ADDENDUM - 01

DATE:06 February 2025
FROM: Scott England AIA
VIA: WeTransfer/Electronic Mail

SUBJECT:
ADDENDUM -01
BUILDING RENOVATION-LINDENWOLD
MIDDLE SCHOOL
RYEBREAD Project #5773A

A106

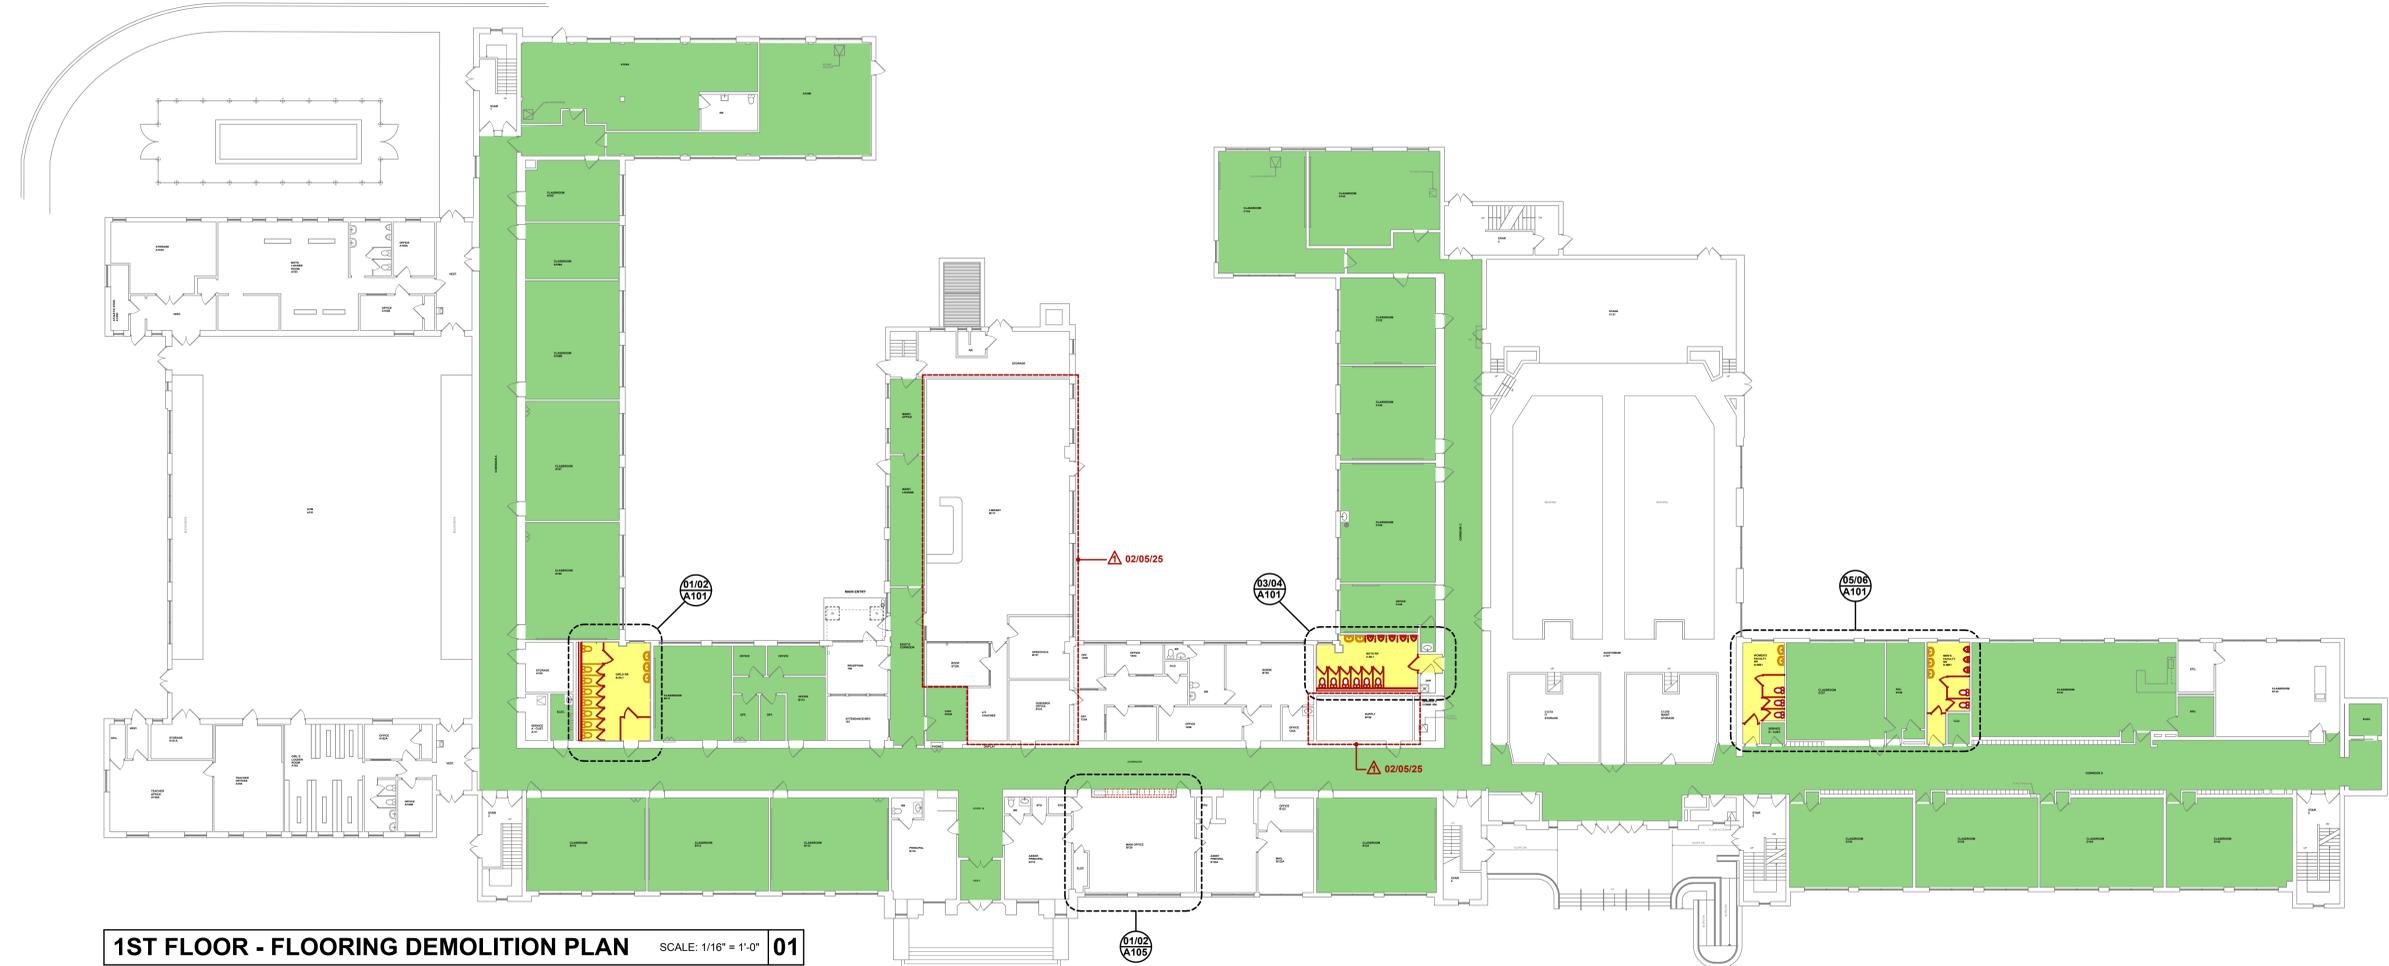
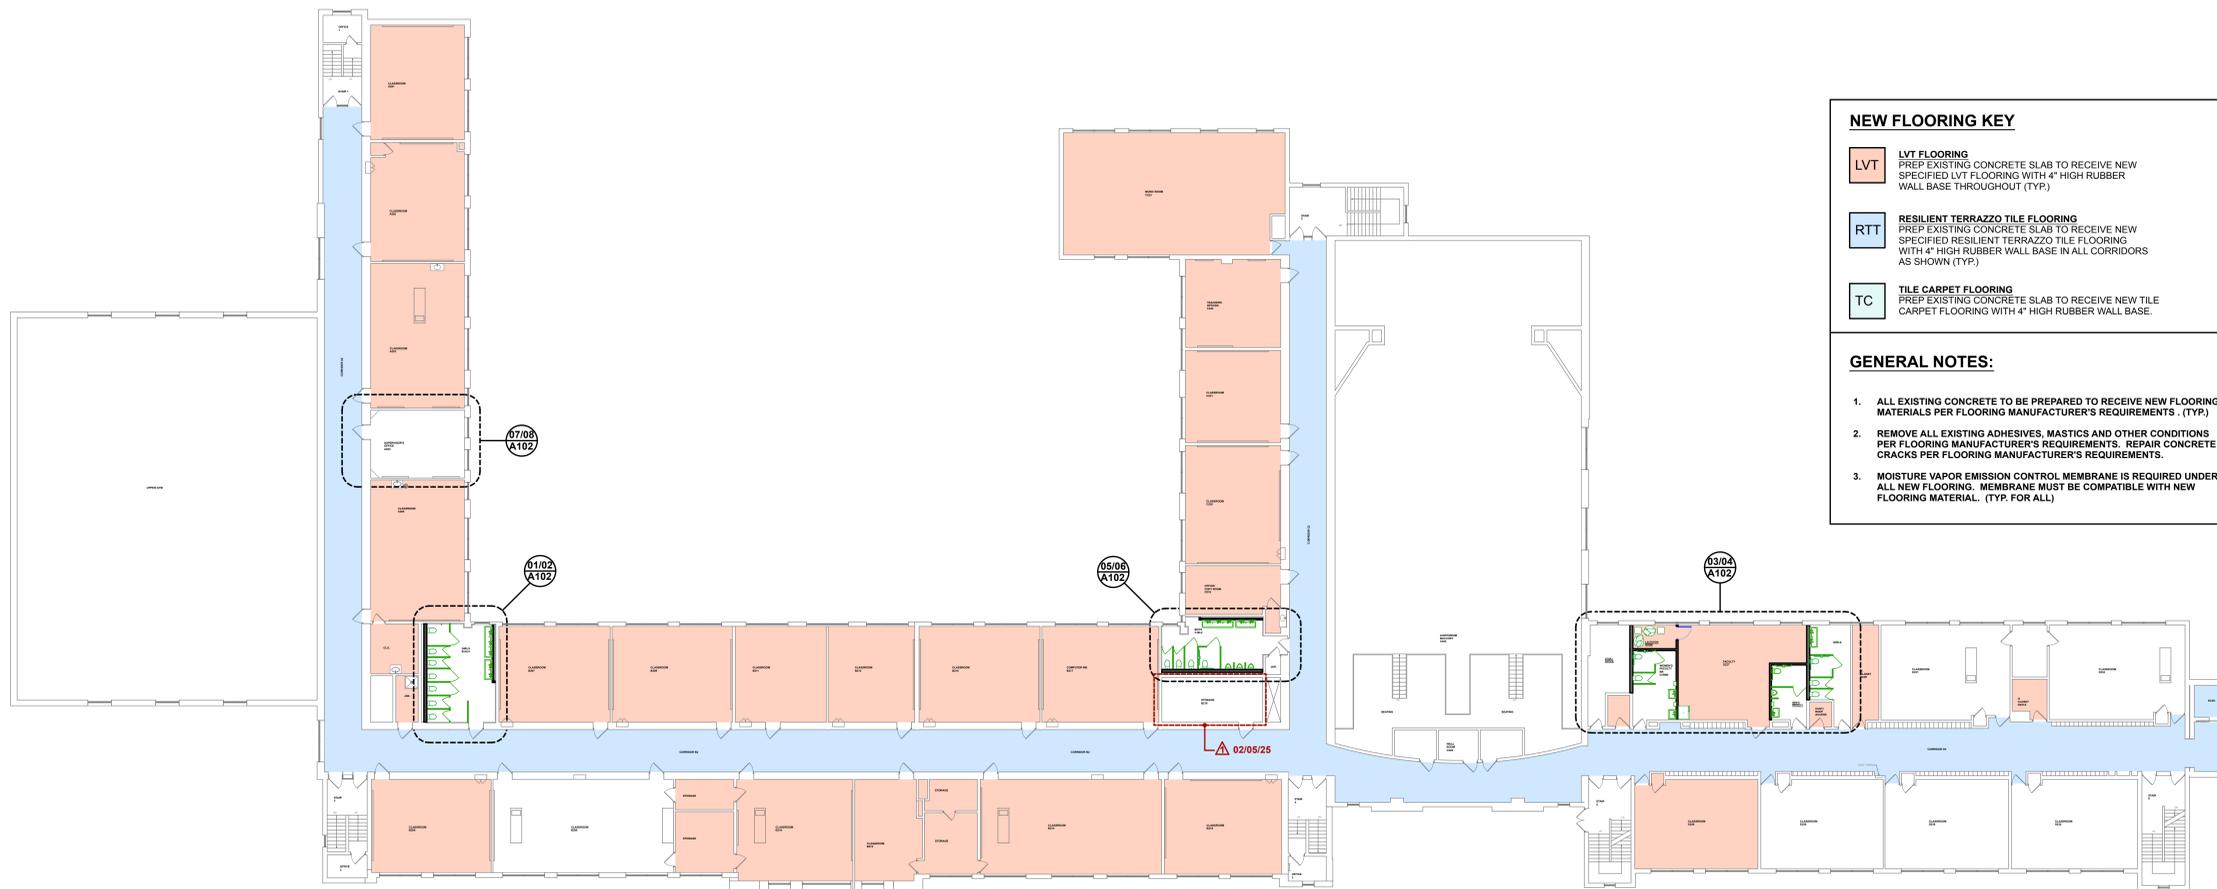
- 1.11 **Deletion:** Delete all work flooring and maintenance repainting scheduled for the Media Center and adjacent spaces and two existing storage closets as shown on attached amended drawings numbered A106, A107 and A108.
- 1.12 **Amendment:** Delete specification section 096519, LUXURY VINYL COMPOSITION TILE FLOORING as bound in the Project Manual.

ED102

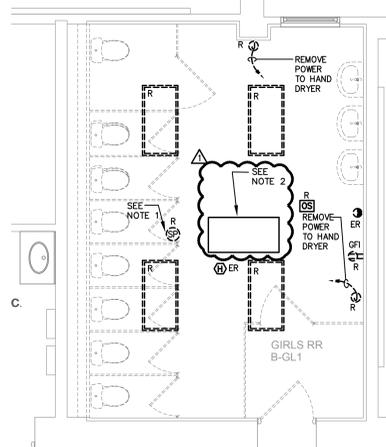
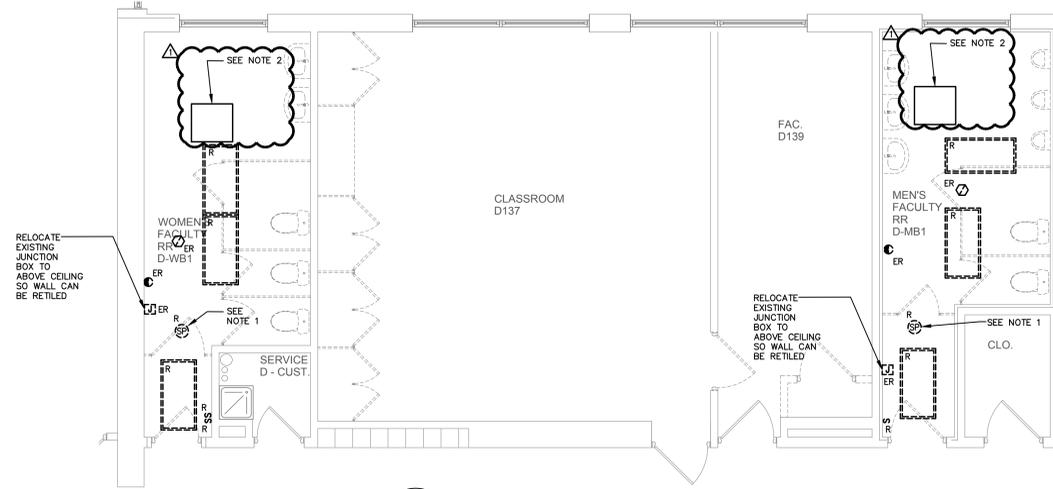
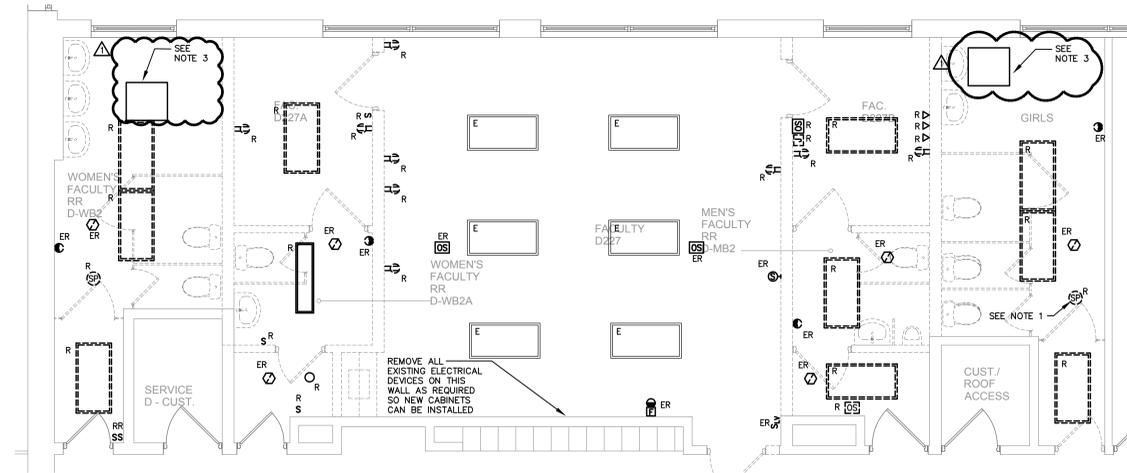
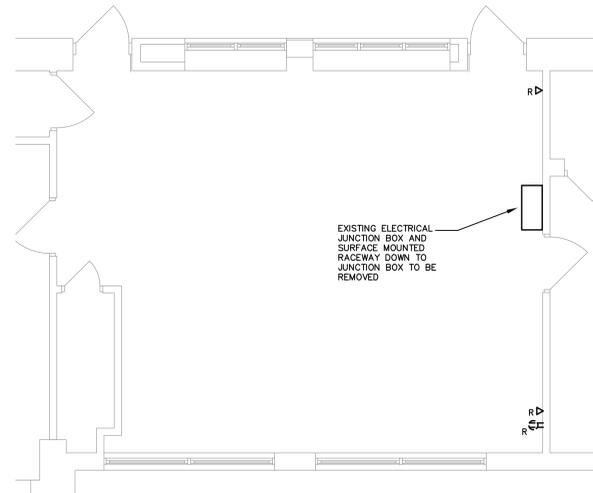
1.02. **Amendment:** See amended and attached electrical drawings ED102, E101, E102, E103, E105, and E106, E301. Amendment date of 06 February 2025.

E101

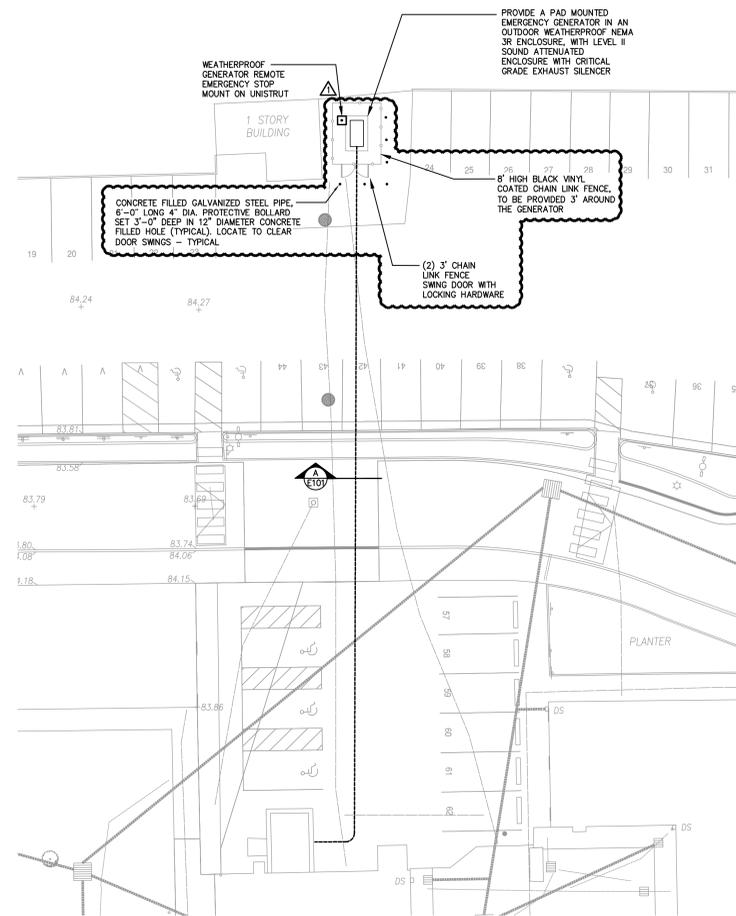
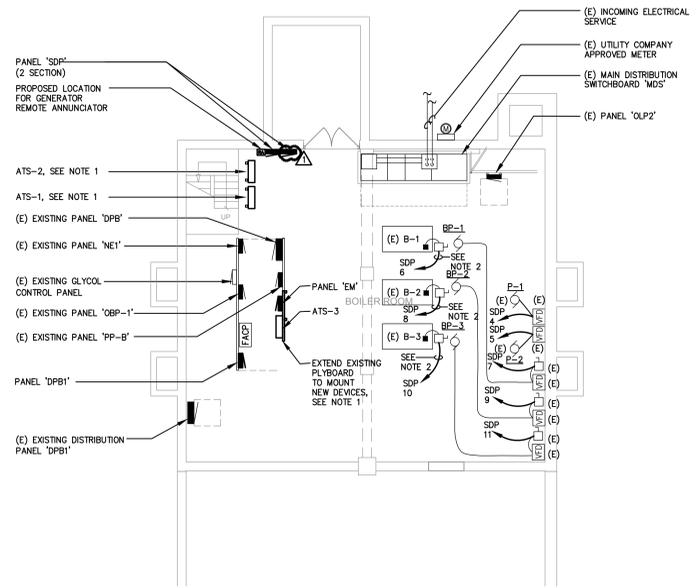
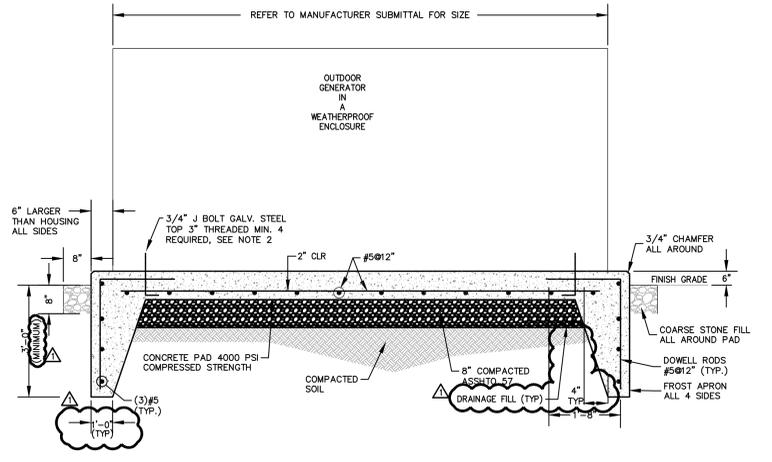
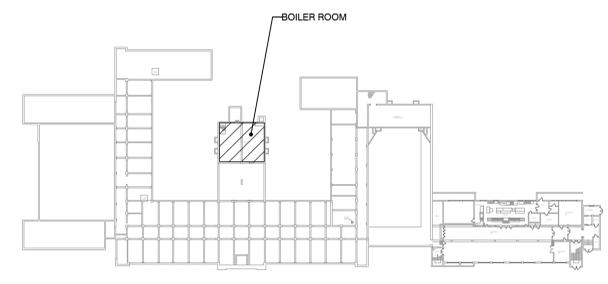
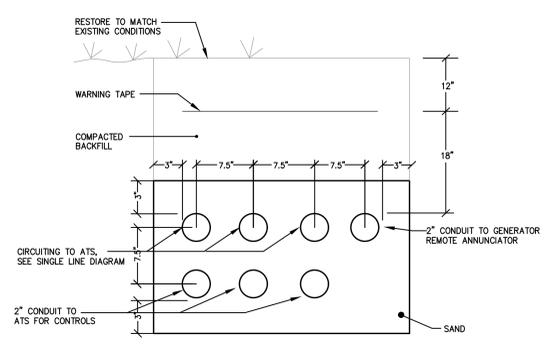
1.04. **Addition:** As part of the Base-Bid, the Contractor to provide a Ground Penetrating Radar (GPR) service and report to locate (mark-out) all existing underground utilities between the Boiler Room and the new generator location. Provide a copy of the GPR Report to the A/E and Owner prior to proceeding with excavation.
